Re: Turkey Point Unit 3  
Docket No. 50-250  
Order (EA-03-009) Relaxation Request  
Examination Coverage of Reactor Pressure Vessel Head  
Penetration Nozzles

**TURKEY POINT UNIT 3 RELAXATION REQUEST  
FROM US NRC Order EA-03-009**

**“Hardship or Unusual Difficulty without Compensating Increase in  
Level of Quality or Safety”**

**Figure 1: Typical RPV Nozzle UT Inspection "C" Scan with area of missed coverage identified by arrows and above the white horizontal line.**

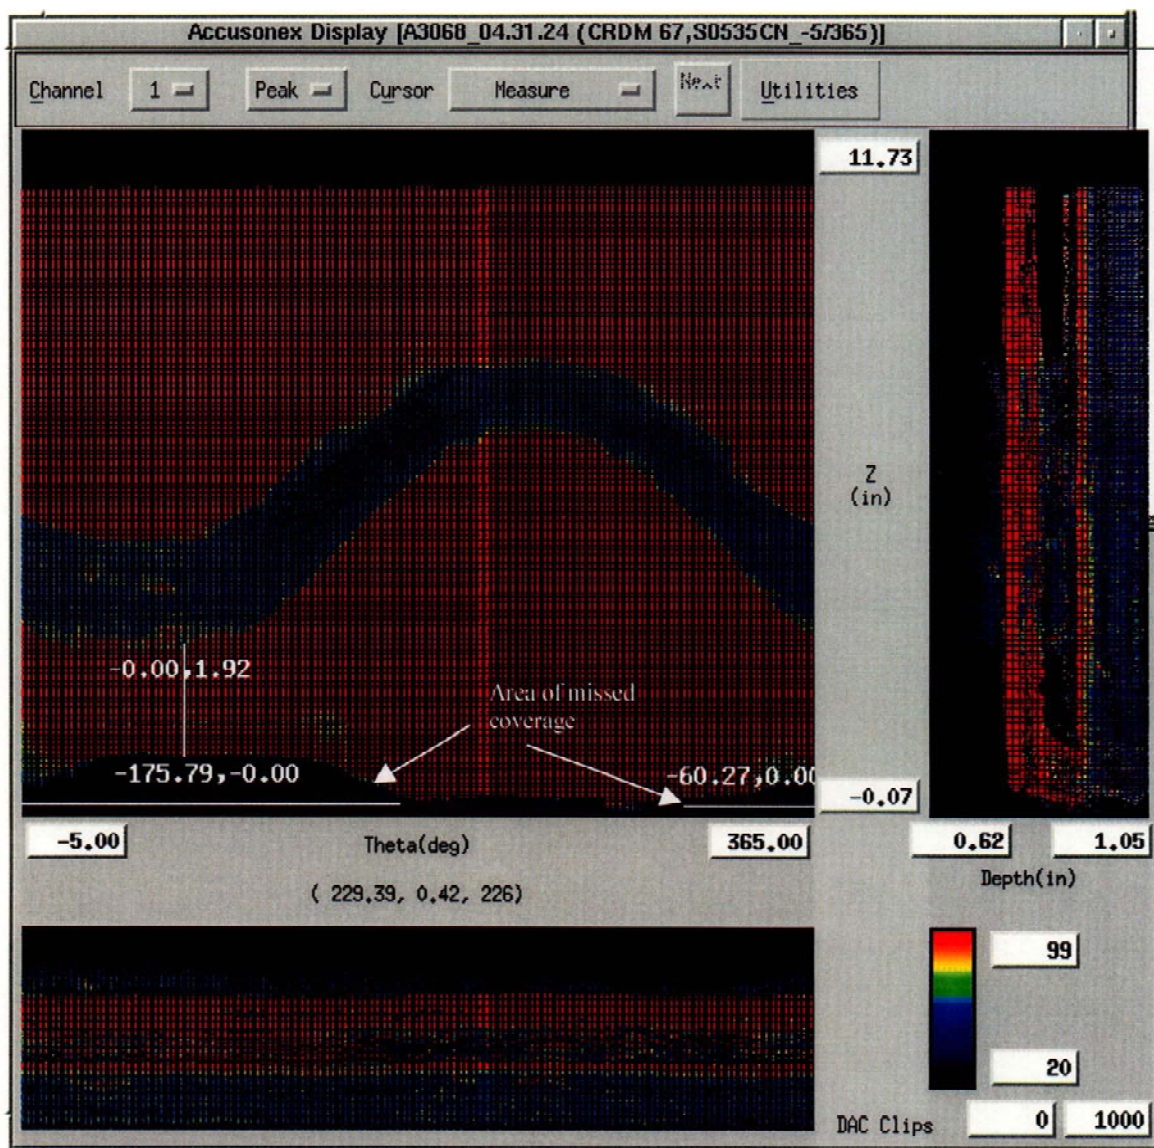
Pursuant to Order Section IV.F.(2) "Compliance with the Order for specific nozzles would result in hardship or unusual difficulty, without a compensating increase in the level of quality and safety", FPL is requesting this relaxation for Turkey Point Unit 3. Currently, with 48 of 66 RPV nozzle penetrations examined, there are 6 RPV head penetrations that contain areas of coverage less than that required by the NRC Order. The Order requires examination from 2 inches above the J-groove weld to the bottom of the RPV head penetration nozzle. The reduced coverage is caused by nozzle configuration, and limitations of the probe design used for the Ultrasonic (UT) examination. Specifically, actual coverage below the weld, in the non-pressure boundary portion of the nozzle, did not in all cases, extend to the "bottom of the nozzle." A typical example of the UT cover area, with the area of missed coverage identified, is shown in Figure 1.

The proposed alternative is to perform the UT examination to the extent practical. This is defined as "the examination shall be performed to include 2 inches above the weld to  $\geq$  1 inch below the weld." This relaxation request documents and submits to the NRC, deviations from the NRC Order required inspection coverage area along with a justification as to their acceptability.

Figure 2: Through-Wall Axial Flaws Located in the 42.6 Degree Row of Penetrations, Uphill Side - Crack Growth Predictions (From Figure 6-19, WCAP-16027-P)

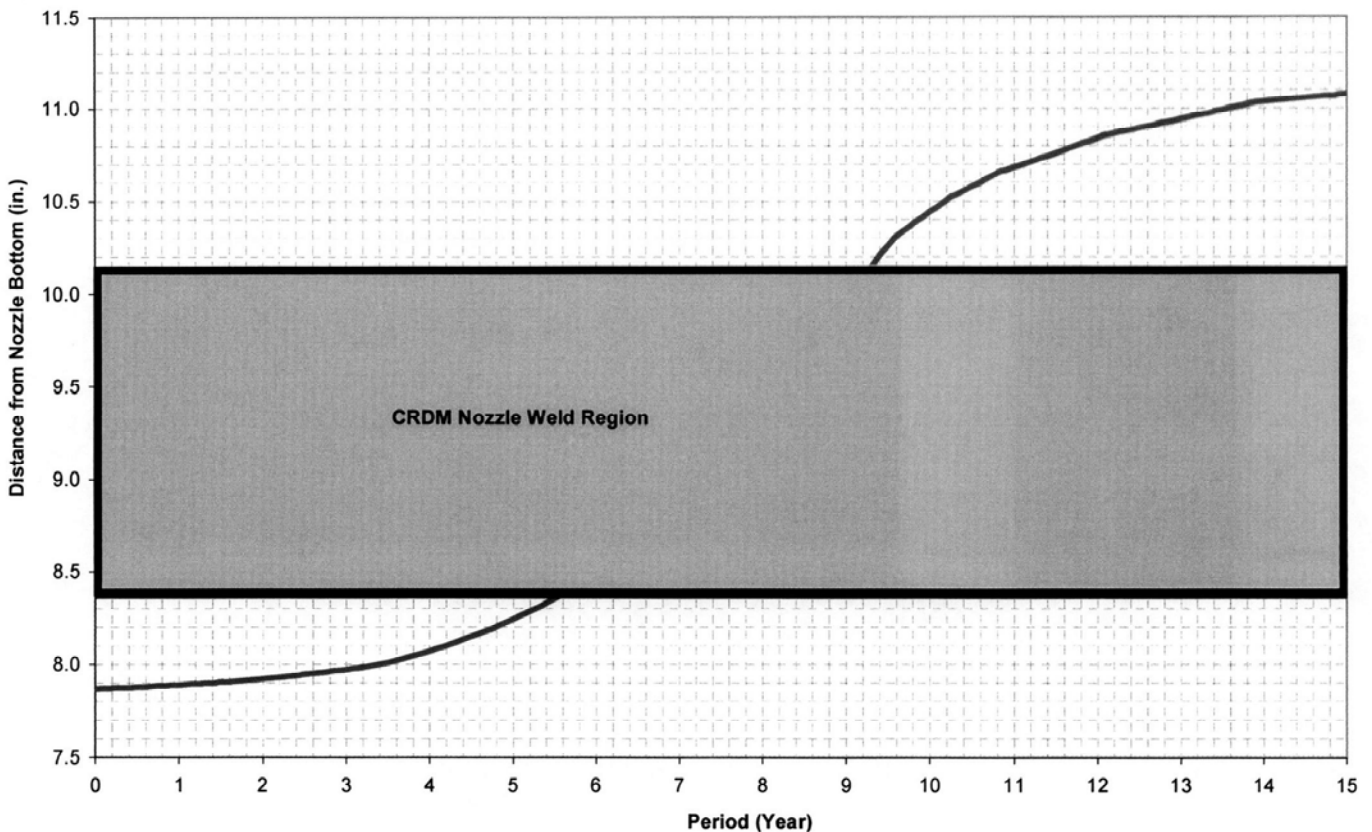
To determine the significance of an axial flaw that is contained in the non-pressure boundary nozzle material in the un-inspected region >1 inch below the weld, a flaw tolerance approach is used. A flaw evaluation was performed postulating an axial flaw in the area of missed coverage below the weld using WCAP-16027-P<sup>3</sup>. A through wall flaw is postulated in the nozzle material from the bottom of the penetration to 1" from the bottom of the weld. The flaw evaluation in WCAP-16027-P is based on Turkey Point Unit 3 and 4 specific stresses in the nozzle penetrations. Since the stresses >1" below the weld are too low to propagate an axial flaw, the WCAP-16027-P flaw evaluations start at ½" below the weld, and evaluate the time to propagate the flaw in the nozzle to the bottom of the weld (start of the pressure boundary portion of the nozzle material or toe of the J-groove weld). Assuming a through wall flaw below the weld, with the flaw end located at ½" below the weld (which is in the area of complete UT examination coverage), an axial flaw would take greater than 5 years of operation (Figures 6-12 through 6-20 in WCAP-16027-P) in any nozzle location to grow to the point of contact with the weld. This time period is significantly greater than the current inspection frequency of every refueling cycle (18 months for Turkey Point Unit 3) identified in NRC Order EA-03-009. As an added conservatism, this evaluation does not attempt to evaluate the time for the axial flaw to grow from the bottom of the weld through the pressure boundary. Figure 2 provides a graphical presentation of the above flaw evaluation discussion for the outer most penetration location.

Therefore, there are no concerns with the structural integrity of the RPV penetration nozzles that could be caused by axial cracking in the missed coverage areas in the non-pressure boundary portion of the nozzle material  $> 1"$  below the weld for a period of  $> 5$  years of operation.
